Product Change Notification

Product Group: Draloric/Beyschlag Resistors /March 8, 2016/PCN-DBR-001-2016 Rev 0

Thick Film Resistors CRCW0201 Top Conductor Width Change

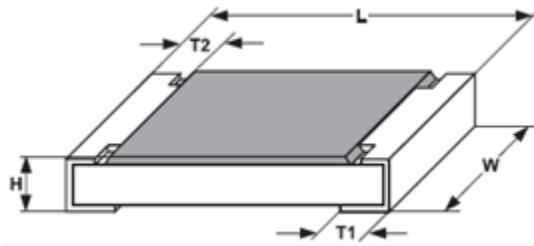
Width of top conductor length (dimension T2 in below drawing) changed from 0.2 +0.05/-0.10 mm to 0.10 ±0.05 mm for CRCW0201.
